**TO:** Mills City Council  
**FROM:** Megan Nelms, AICP, City Planner  
**DATE:** February 25, 2025  
**SUBJECT:** Vision Beyond Borders – Development Plan

**Case Number:** 24.04 DEV

**Vision Beyond Borders  
Commercial Development Plan**

# SITE PLAN FOR VISION BEYOND BORDERS IN THE CITY OF MILLS NATRONA COUNTY, WYOMING

*Exhibit*  
Proposed Paving

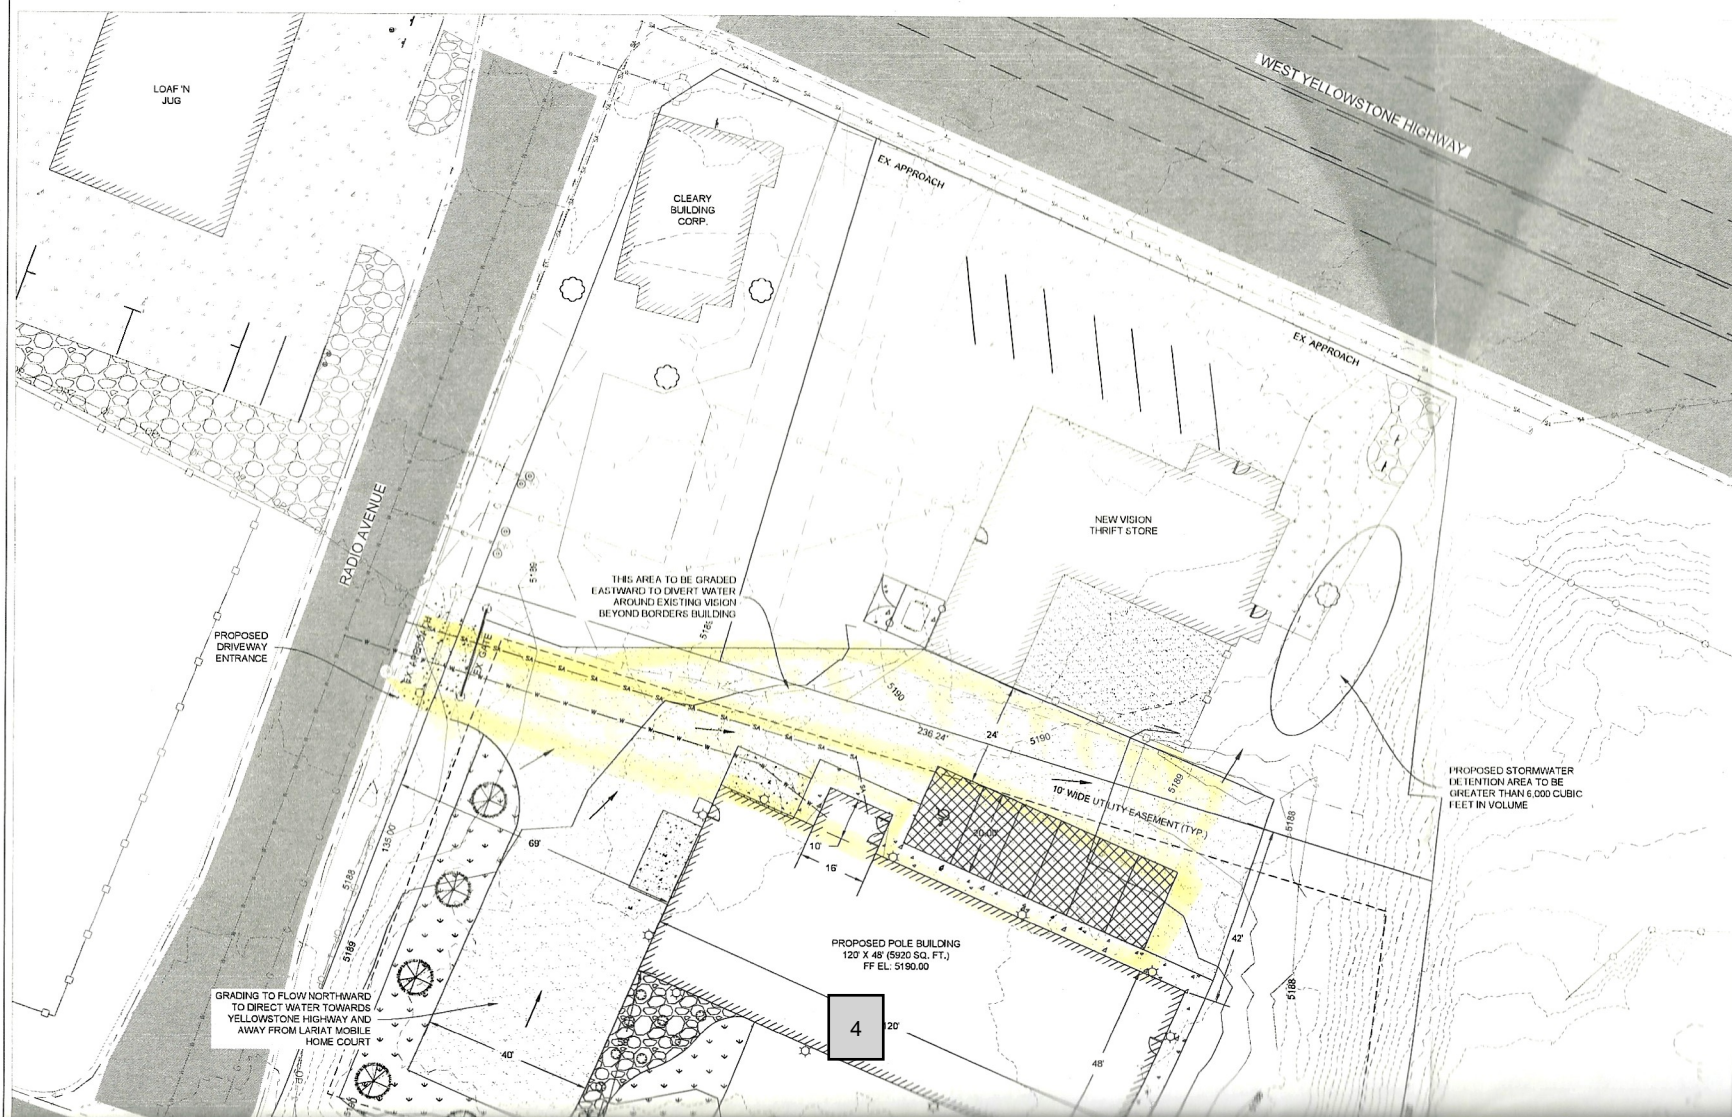
Vision Beyond Borders has made a request to be allowed to delay paving of the entire parking area. Section 40.10(14) allows the City Council to review off-street parking exception requests. VBB has requested up to five years from approval of the Development Plan to pave the parking area for the new building. The Planning Commission reviewed the request and made a recommendation to Council to allow VBB to delay paving the entirety of the parking area, however, they recommended that VBB be required to pave the required parking spaces and the drive/access aisle prior to occupancy of the building. The area recommended to be paved immediately is highlighted in yellow on the attached exhibit.

**Staff Recommendation:** Staff’s recommendation is to require paving of all the required parking area prior to occupying the new building. All other requirements

**SITE PLAN  
VISION BEYOND BORDERS  
MILLS, WY**

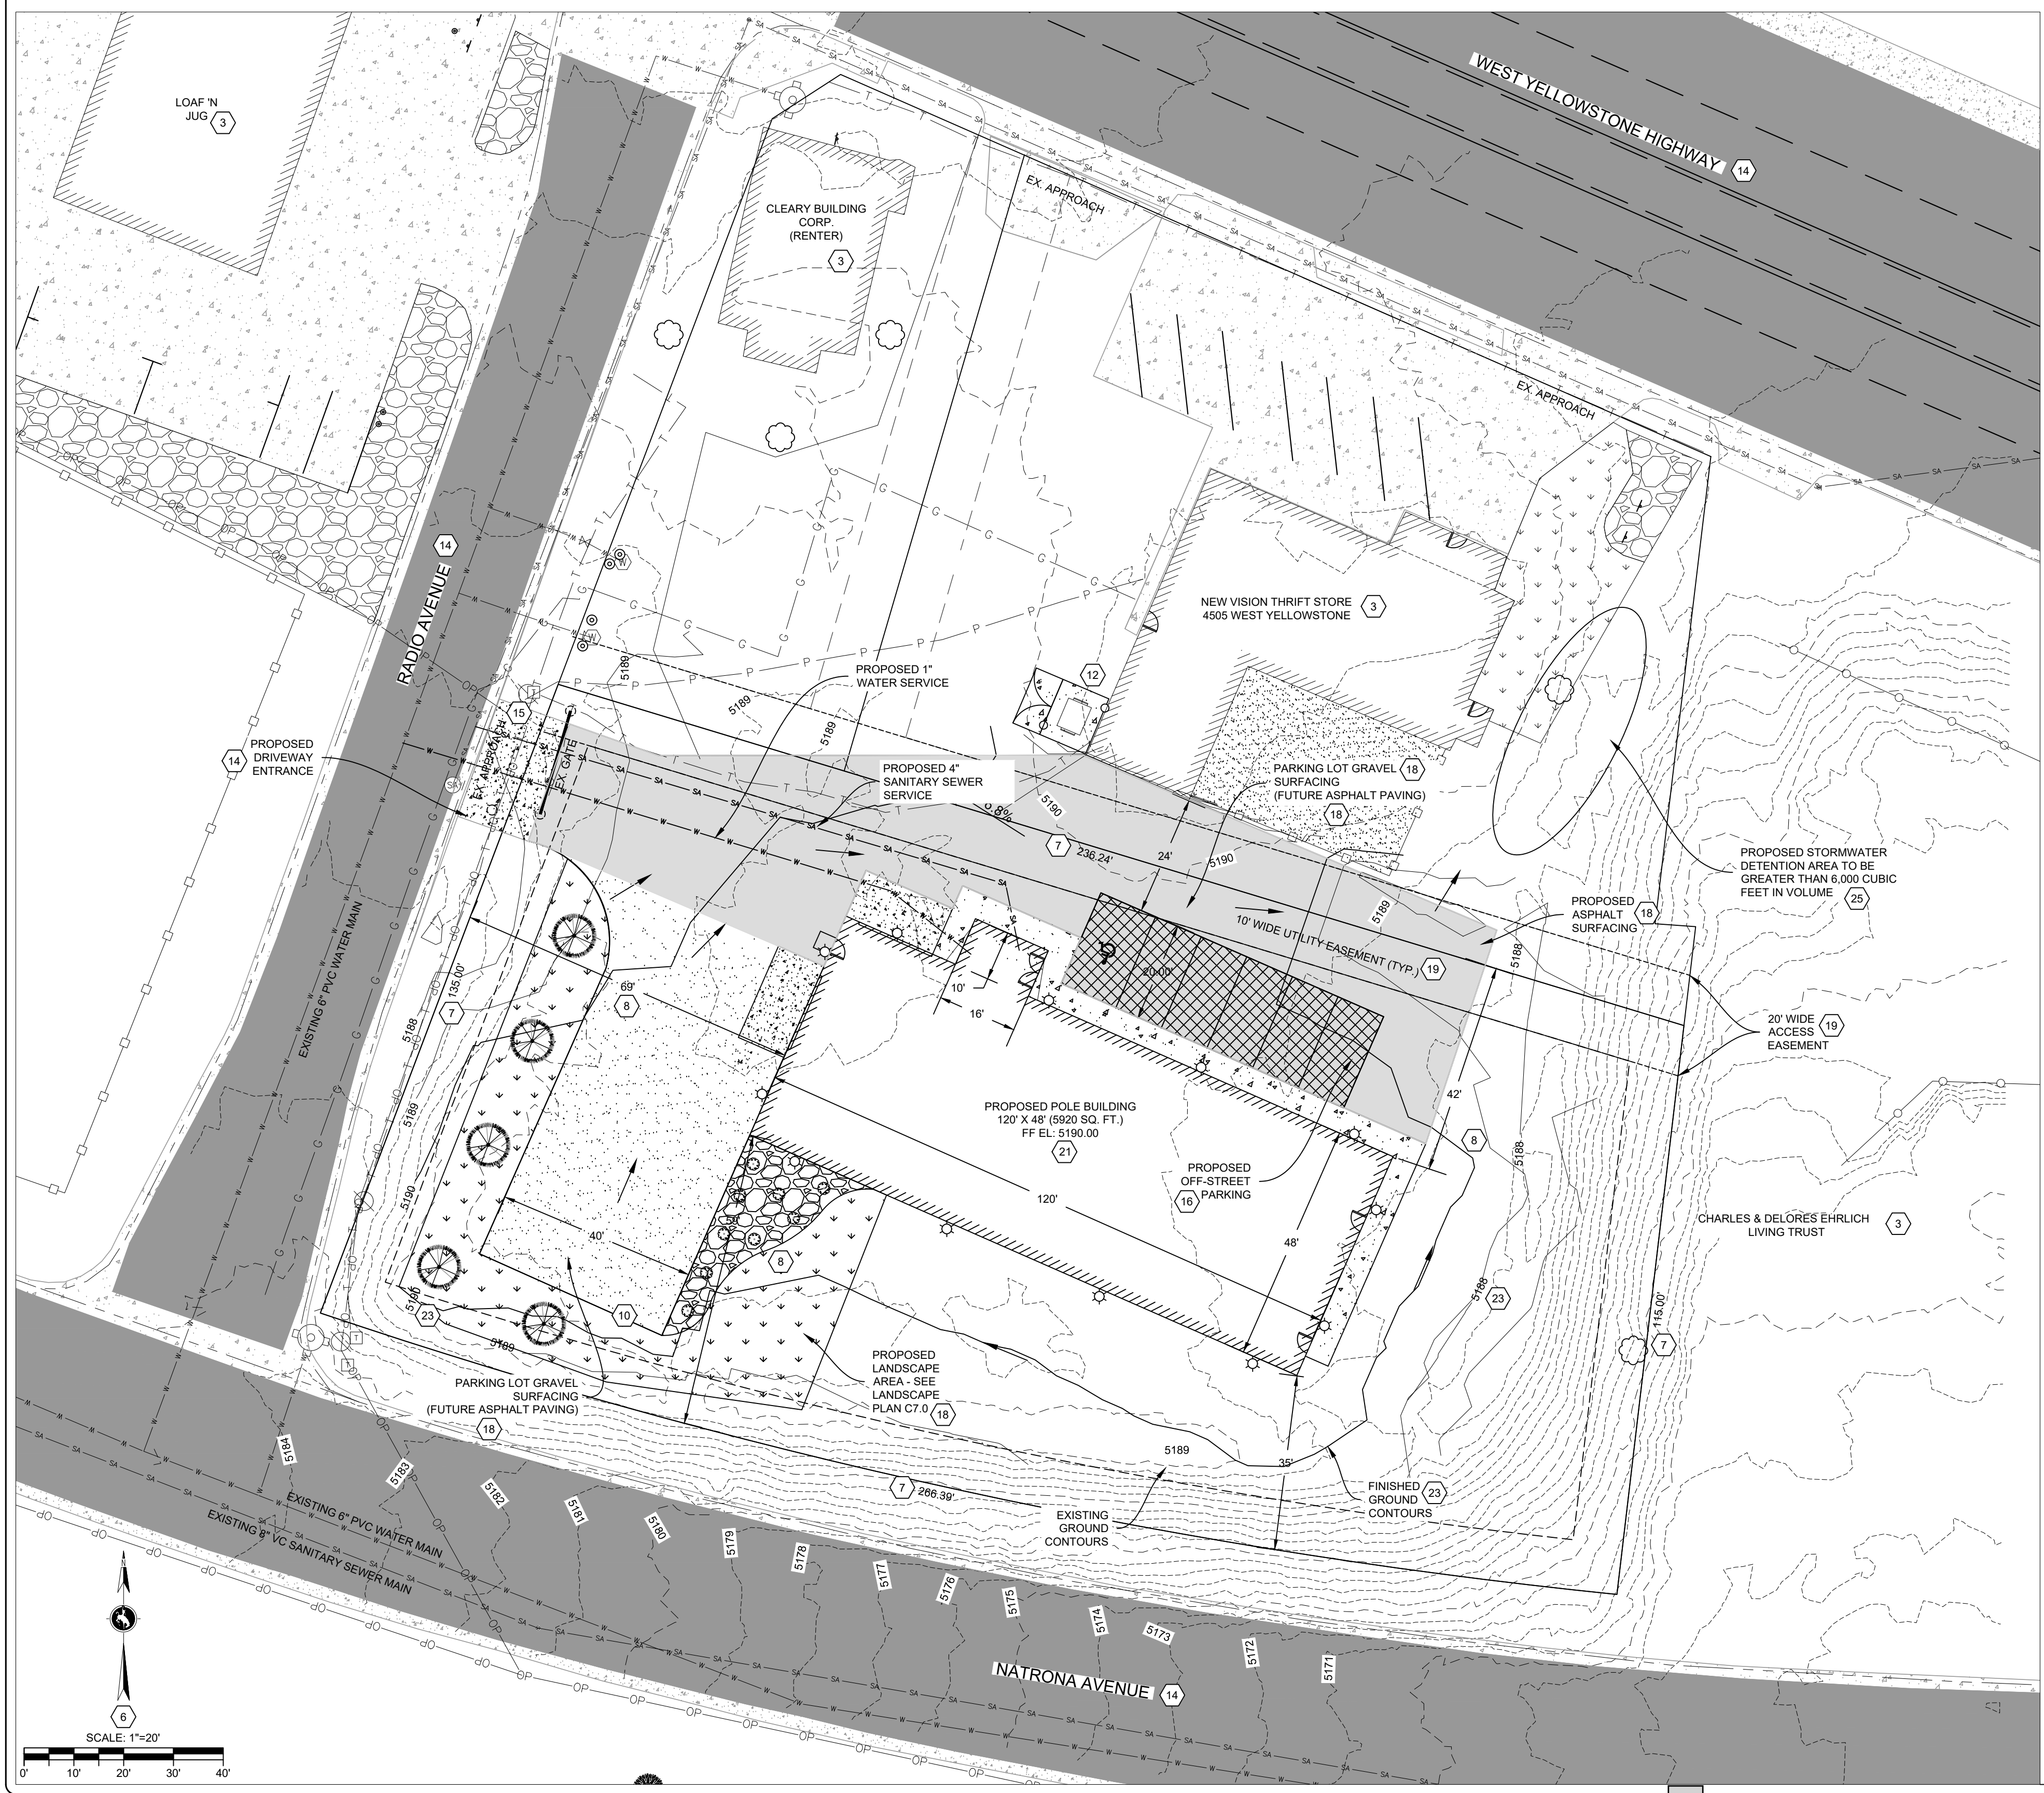
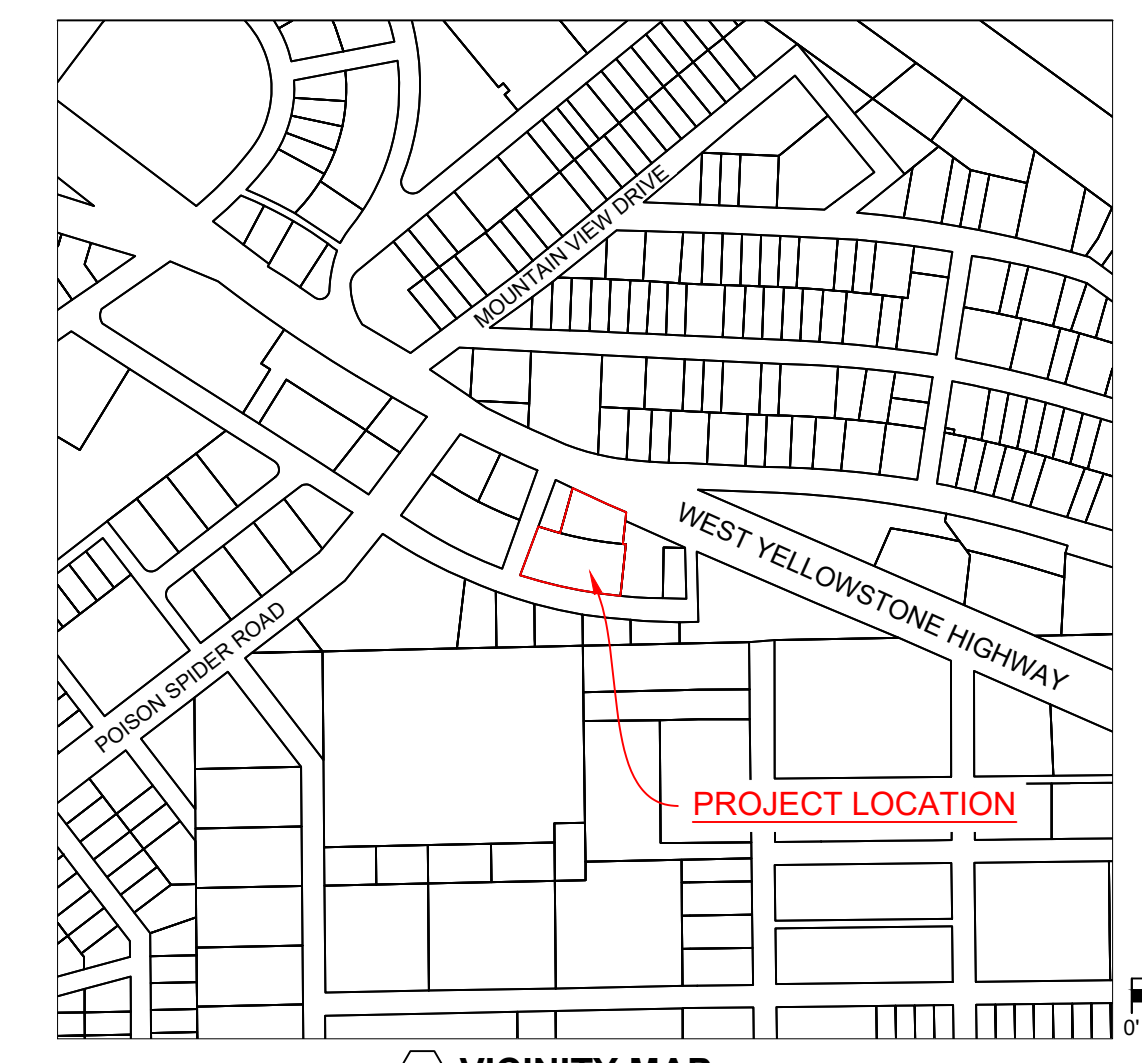
The submitted Development Plan depicts the required six (6) parking spaces as paved, however, the applicant has indicated on the Development Plan and in the application their intention to utilize gravel surfacing across the remainder of the site, with plans to pave in the future. The Commission should evaluate this request and either include a recommendation to Council to allow an exception to the paving requirement or request a revision of the application to show a fully paved surface at time of construction.

3. Per Section 40.10(6) all required parking spaces and all driveways, entrances and exits from the parking area shall be paved with asphalt, concrete or similar permanent surface.

There was general discussion about the lot lines and a shared access and utility easement shown on the plat. Board Member Bryson stated that the site plan shows vehicles on the access drive to the parking area will be crossing over the lot line a bit and he doesn't want to see any issues if there are ever two different owners of the parcels.

Staff recommends APPROVAL of the Development Plan if all requirements of the LDRs are met, including paving of all entrances, exits and required parking area and all other planning considerations are completed and met.
